Model: Neptune-C2	Date: 31-May-07	No.: RB286001b
--------------------------	-----------------	----------------

Subject: Firmware Release Note: Engine		Prepared by: F.Noguchi	
From: 2nd Tech. Support Sec. Service Support Dept.			
Classification:	<input type="checkbox"/> Troubleshooting	<input type="checkbox"/> Part information	<input type="checkbox"/> Action required
	<input type="checkbox"/> Mechanical	<input type="checkbox"/> Electrical	<input type="checkbox"/> Service manual revision
	<input type="checkbox"/> Paper path	<input type="checkbox"/> Transmit/receive	<input type="checkbox"/> Retrofit information
	<input checked="" type="checkbox"/> Other ()

This RTB has been issued to announce the firmware release information for the **Engine**.

Photo: Before the modification (harness for 2-roll roll feeder).

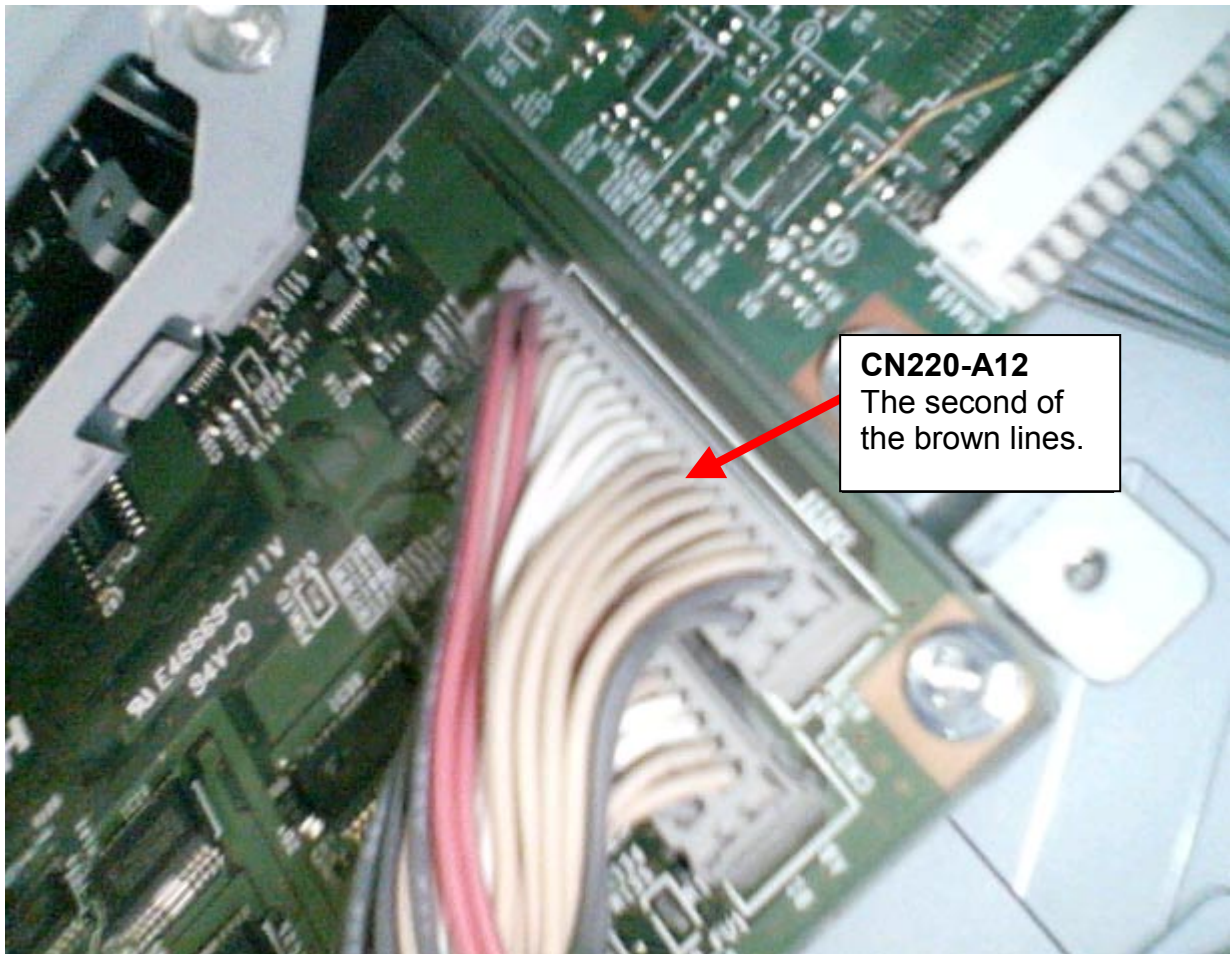
- Roll Feeders Type A and B were both modified to support the N-C2. However, there may be a small number of Type A roll feeders still in the field which were produced before the modification.
- The part numbers of the harnesses are as follows:

- Replace the harness with one that supports the N-C1 and N-C2, OR
- Do the modification on the next page. This will make it possible to use the Type A Roll Feeder on the N-C2.

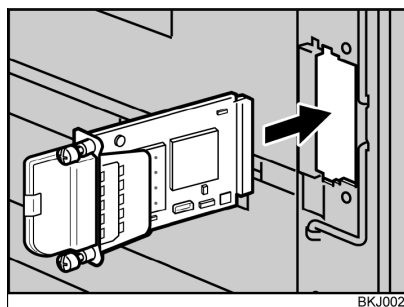
Previous types:
PCB, LAN card, and cover are
separate

New Type (IEEE802.11b
Interface Unit Type N):
Pre-assembled

How to distinguish the new parts from the old parts

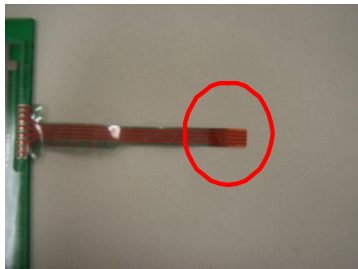
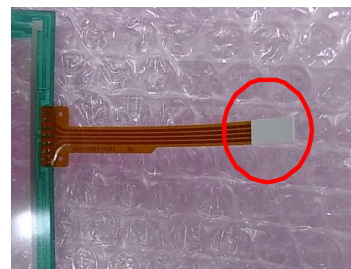
The tip of the electrode is **brown**.

The tip of the electrode is **white**.

5. Place the new touch panel (P/N **B2231484**) on the operation panel cover.

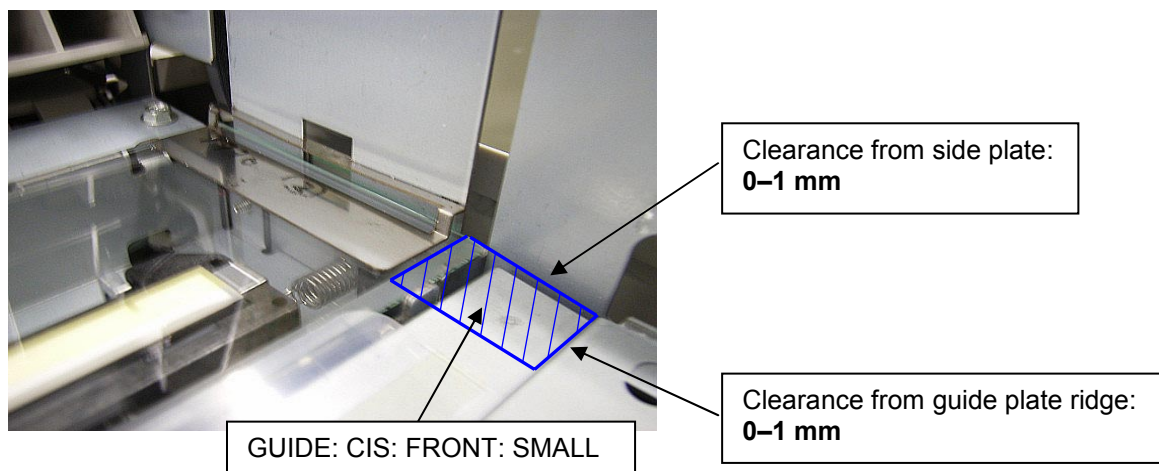
Change: A thin guide plate (Mylar) was added as shown below.

Reason: To further protect the operator-side edge of the exposure glass.

Note: The Mylar shown in the photo is attached to the right corner, operator side. There is also one more attached to the left corner.

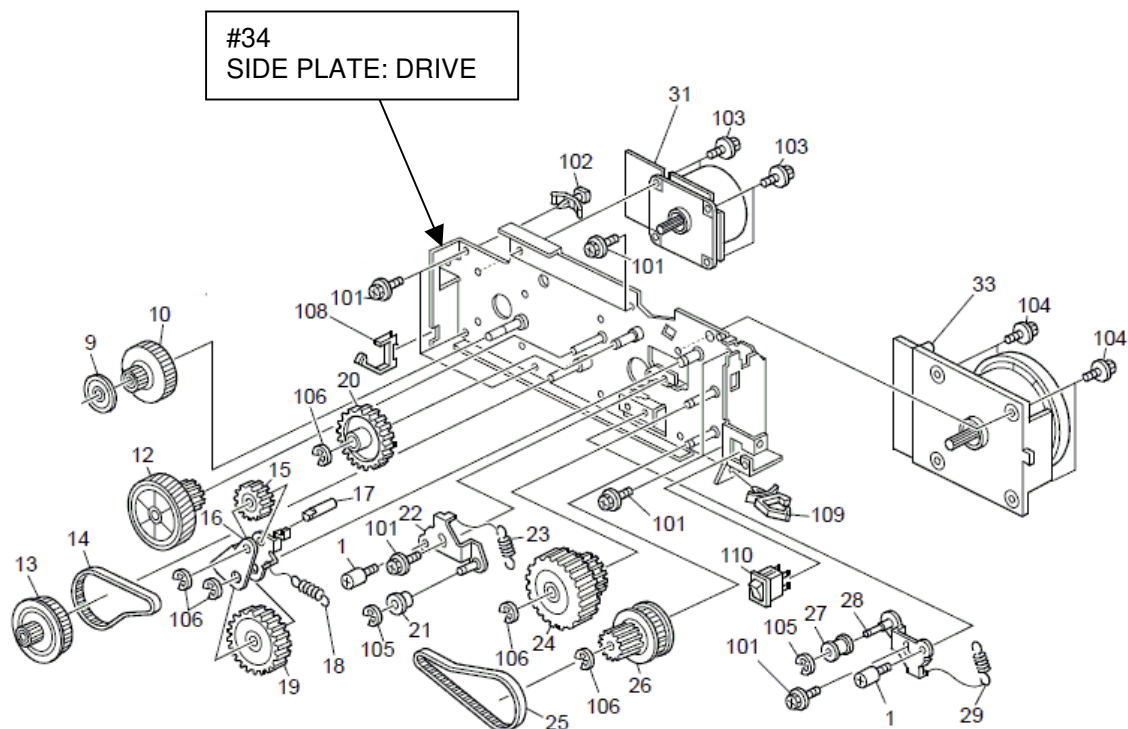
Change: The side plate was added.

Reason: In accordance with requests from the field.

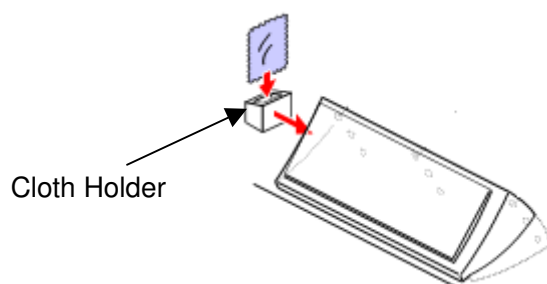
Change: The cloth holder is now bundled at the factory from May 2010 production.

Reason: In accordance with requests from the field.

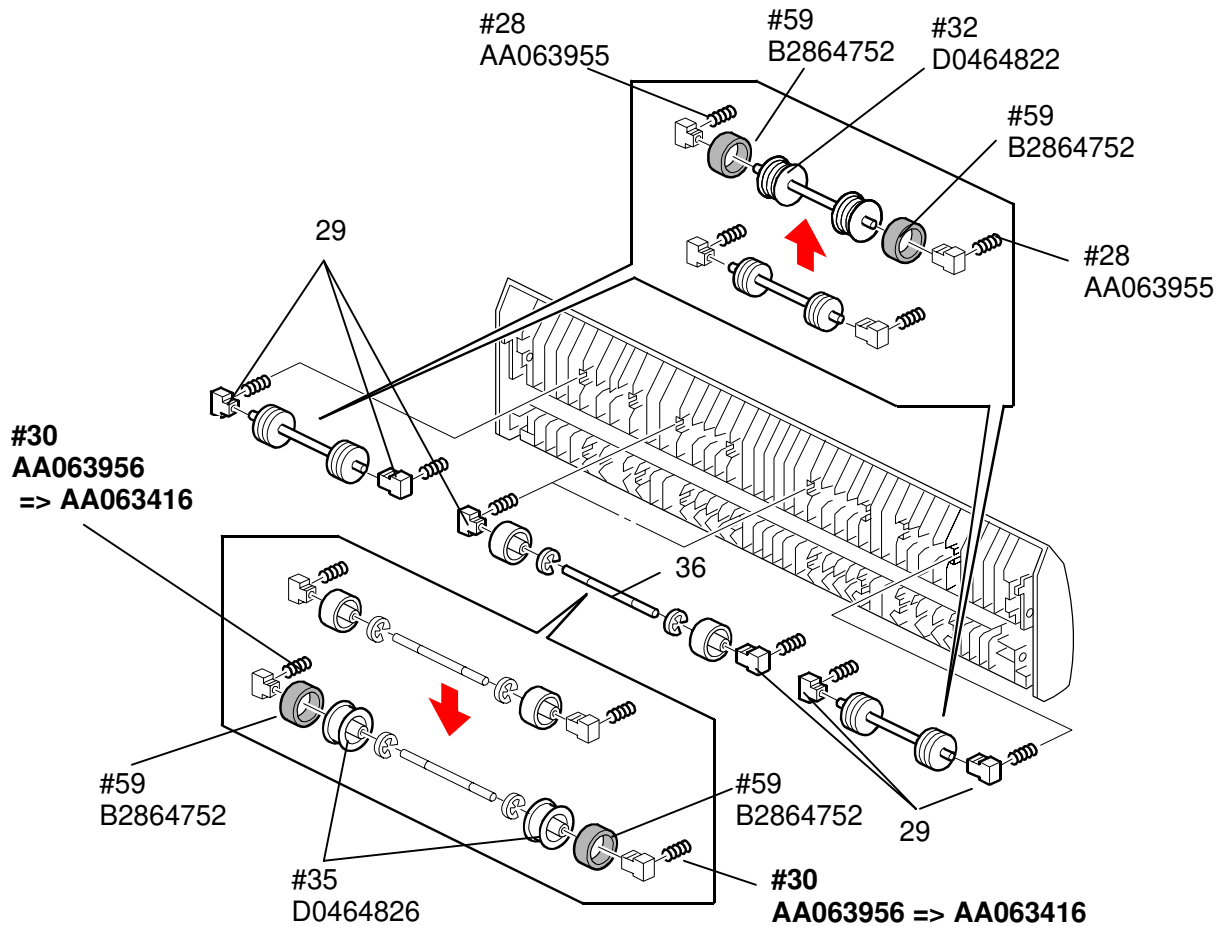
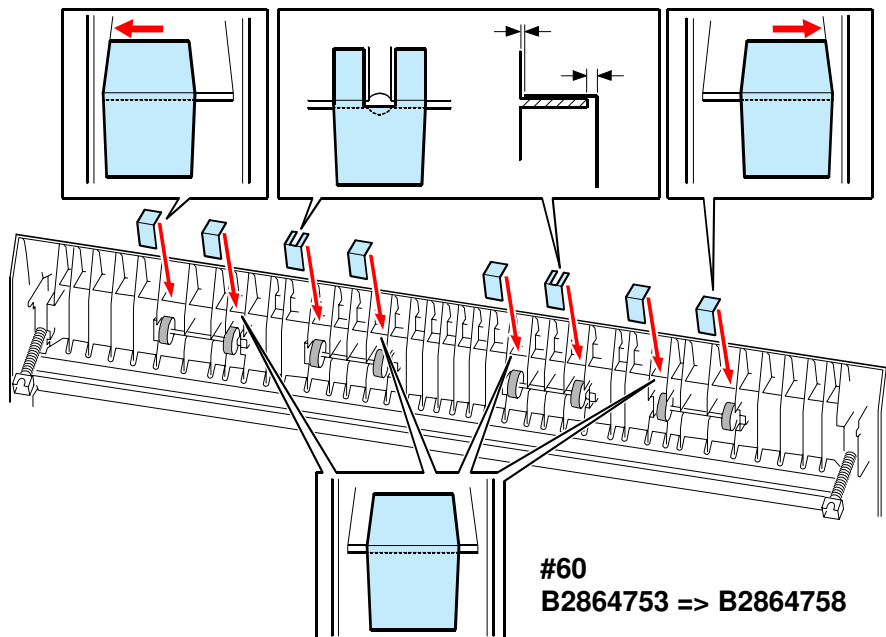
#60
B2864753 => B2864758

#61
B2864754 => B2864757
